MODBAR TECHNICAL BULLETIN  
#23  
Modbar AV Drainbox cover

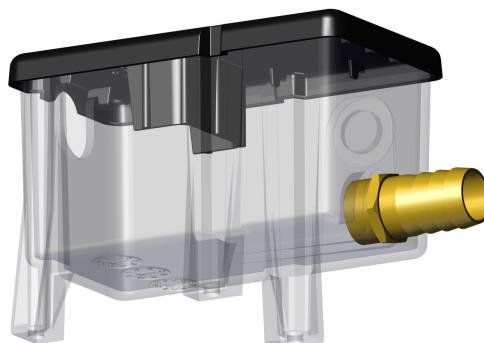
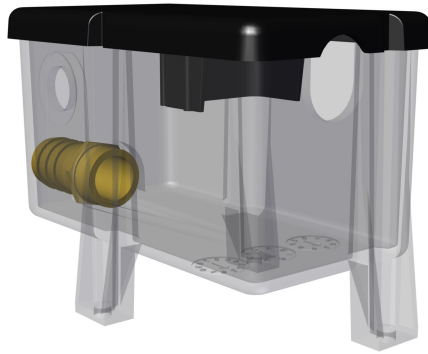
AV modules will now come with a modified drain box cover. The new cover directs the water downwards, reducing the likelihood that water will escape during backflushing of the second tap.

The original part code **F.1.116** will be replaced with part code **F.1.116.01**.

This change will be introduced from serial number AV0003004. The new cover is completely interchangeable with the original.
